SUBJECT: TECHNICAL SPECIFICATION 3.4 BASES REVISION - OCONEE NUCLEAR  
STATION, UNITS 1, 2, AND 3

**SUBJECT: TECHNICAL SPECIFICATION BASES REVISIONS - OCONEE NUCLEAR  
STATION, UNITS 1, 2, AND 3**

Enclosure: Bases Change

Oconee Nuclear Station  
Figure 3.5.2-16a

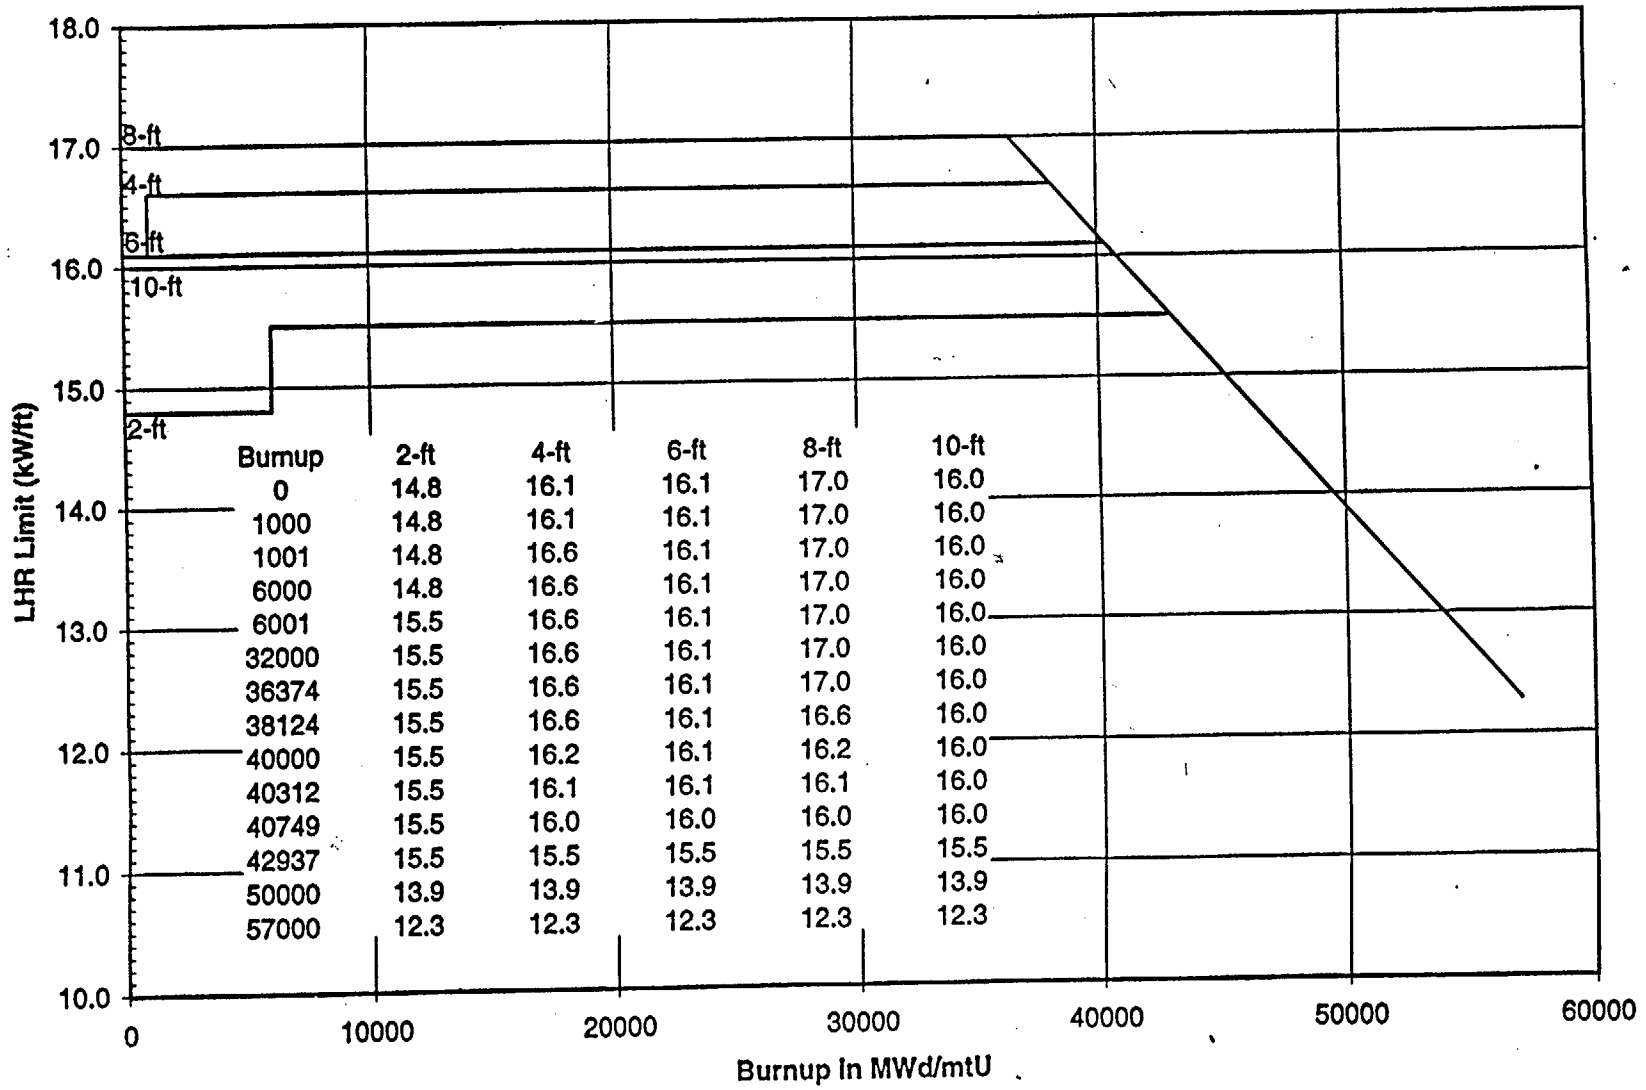
### LOCA LHR Limits for Mk-B8 Fuel (applicable only for O3C17)

Revised by NRC Letter  
dated November 19, 1998

Oconee Nuclear Station  
Figure 3.5.2-16b

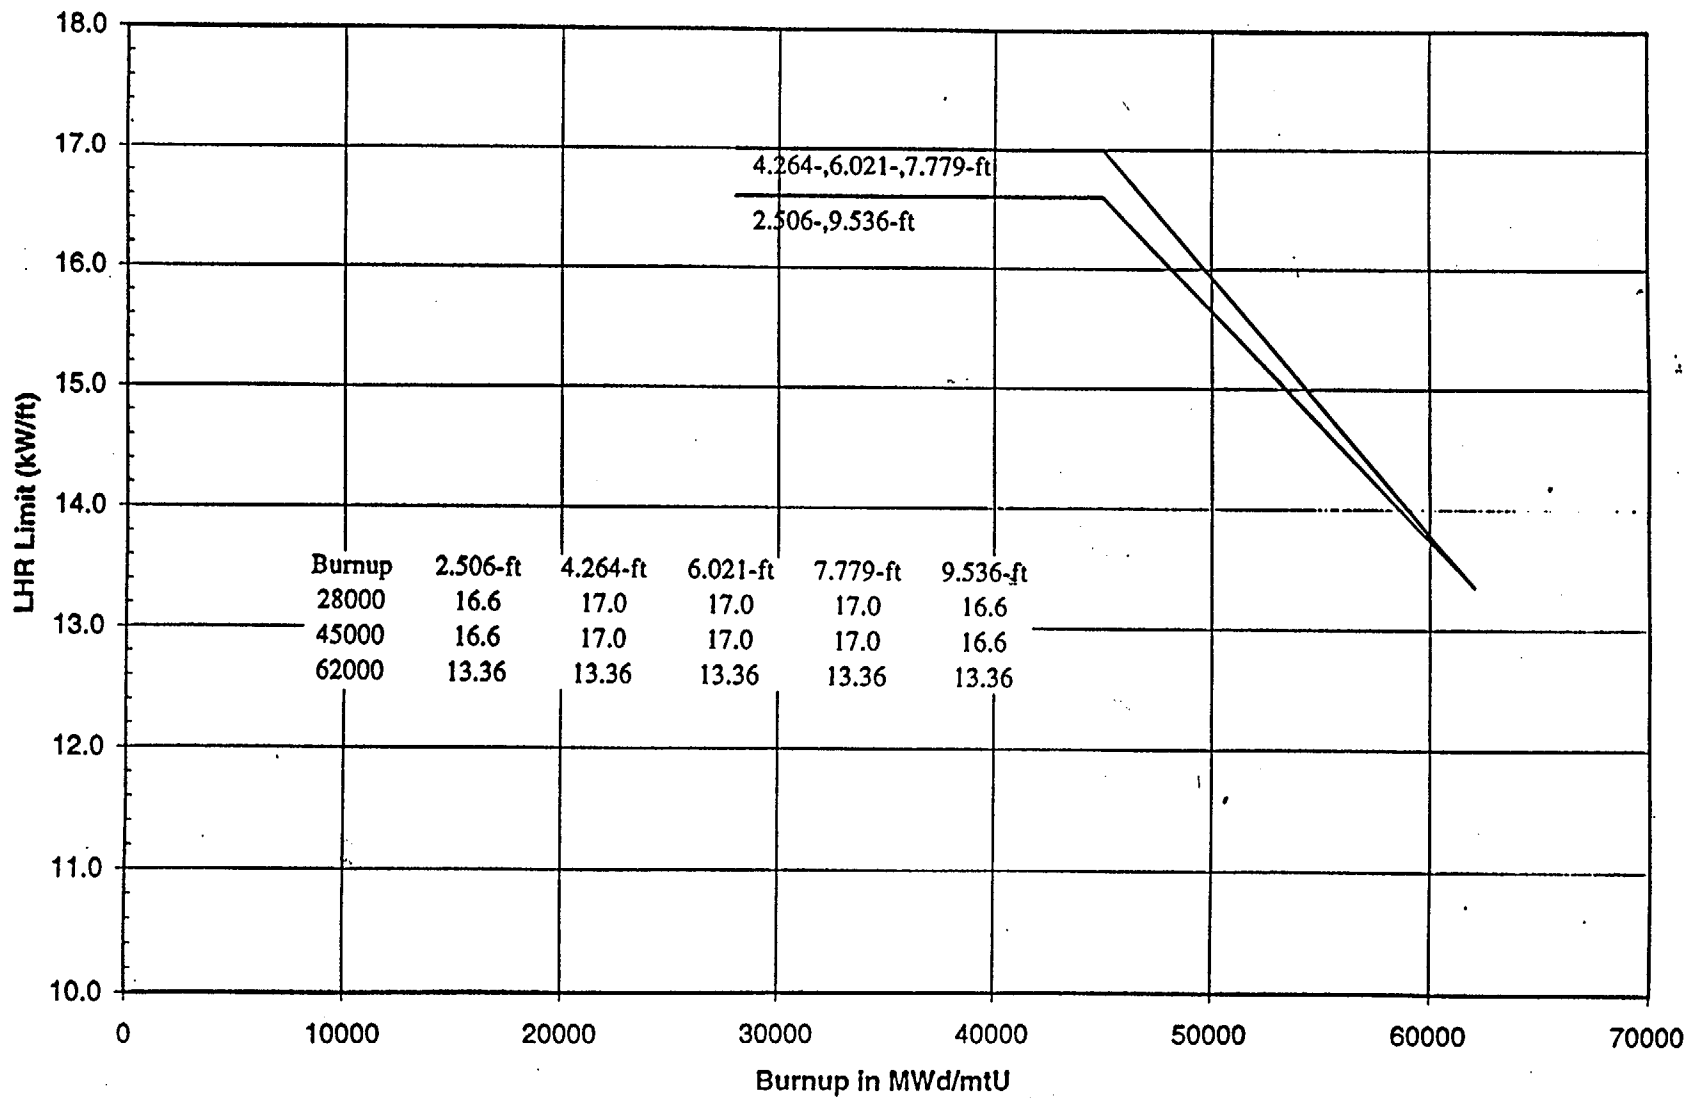
### LOCA LHR Limits for Mk-B9 Fuel

Revised by NRC Letter  
dated November 19, 1998

Oconee Nuclear Station  
Figure 3.5.2-16c

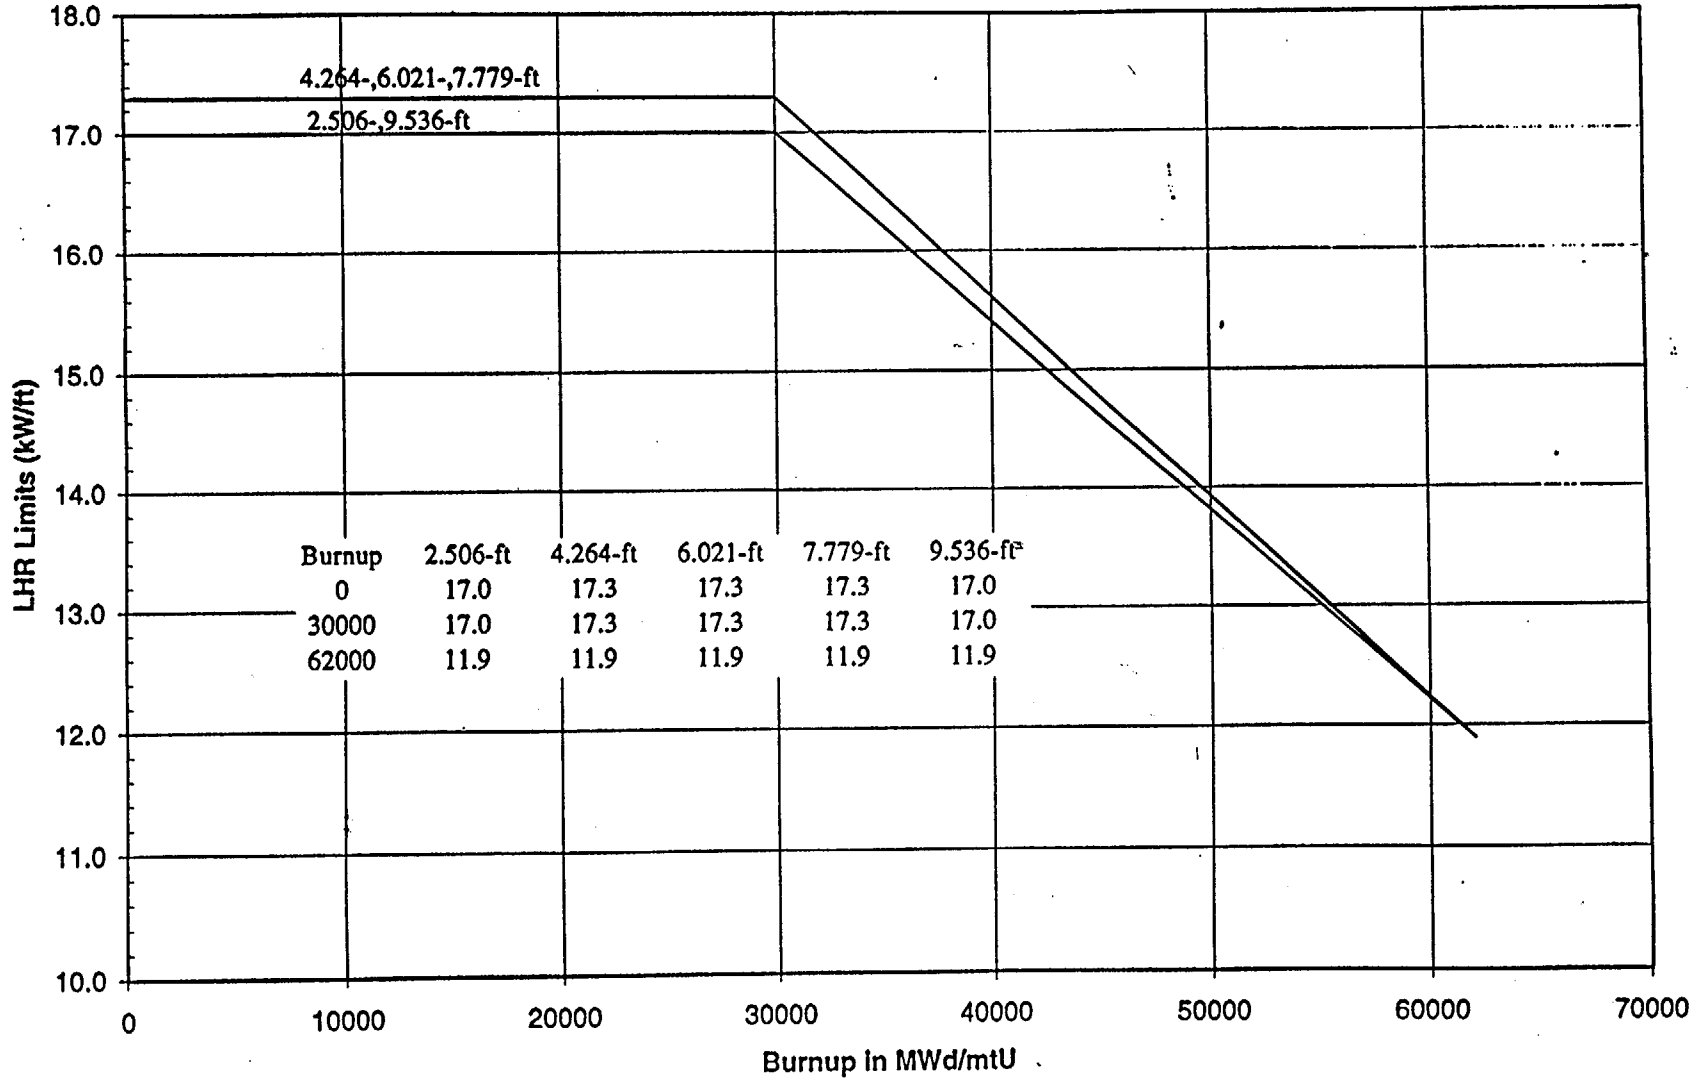
### LOCA LHR Limits for Mk-B10 Fuel

Revised by NRC Letter  
dated November 19, 1998

Oconee Nuclear Station  
Figure 3.5.2-16d

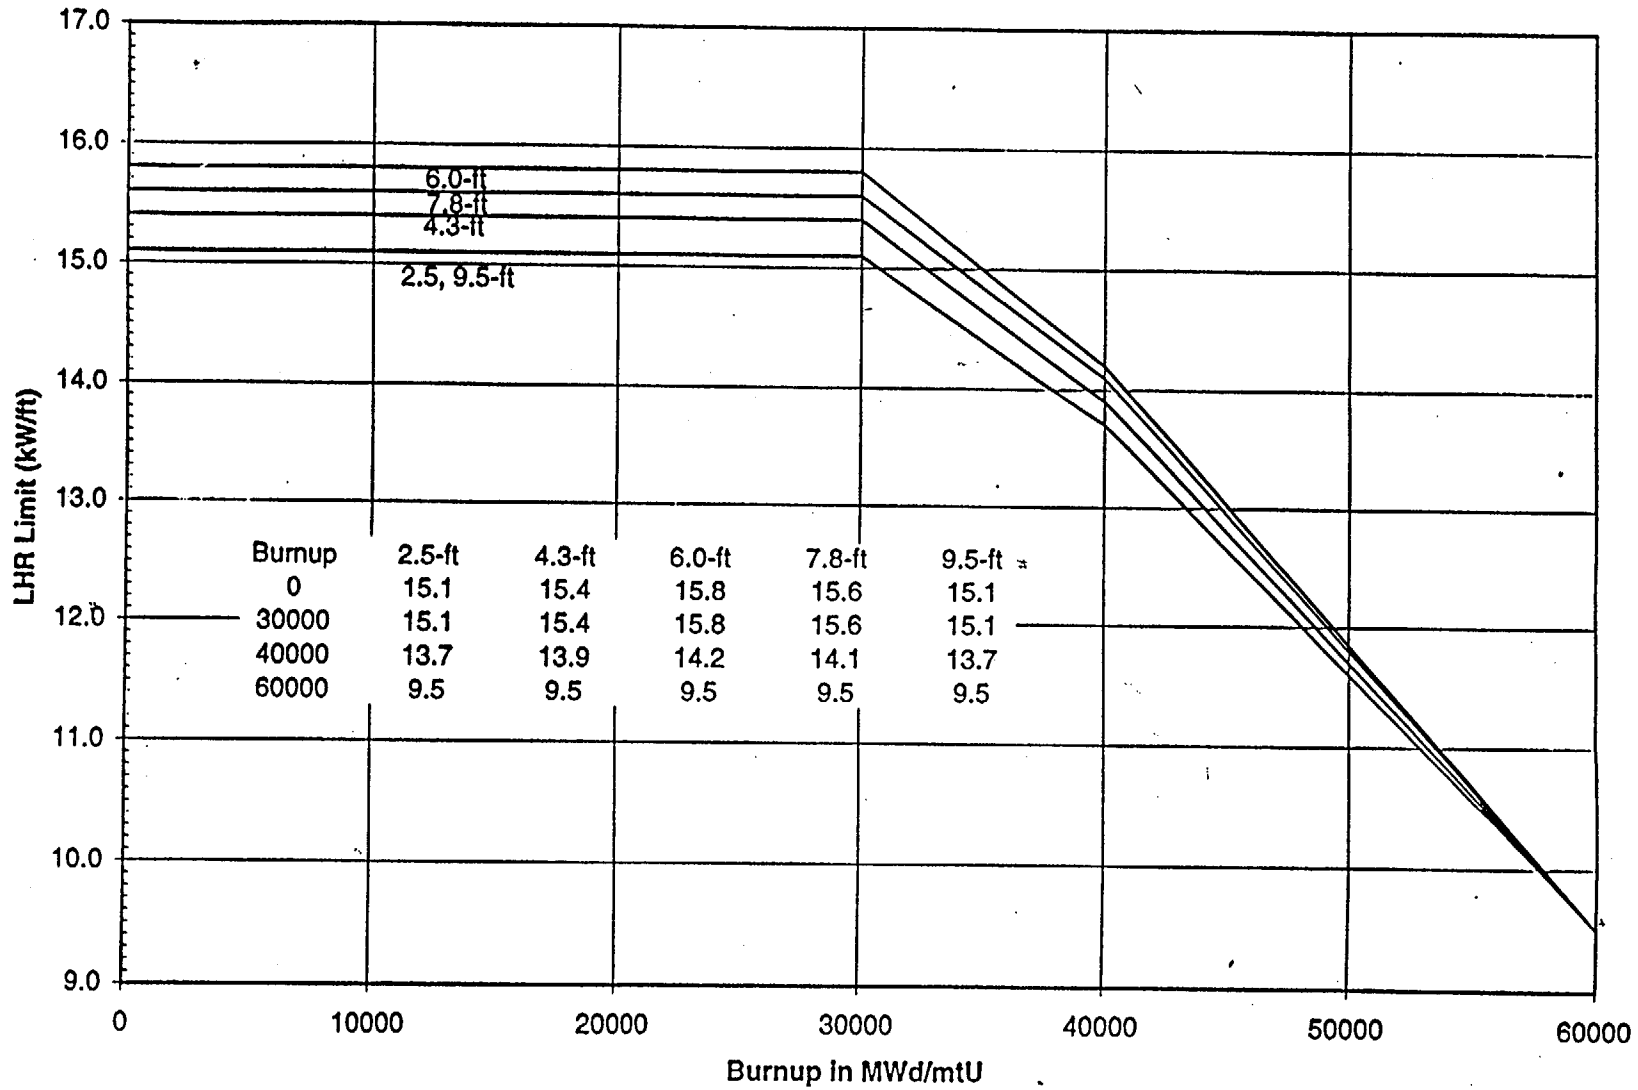
### LOCA LHR Limits for Mk-11 LTA Fuel

Revised by NRC Letter  
dated November 19, 1998
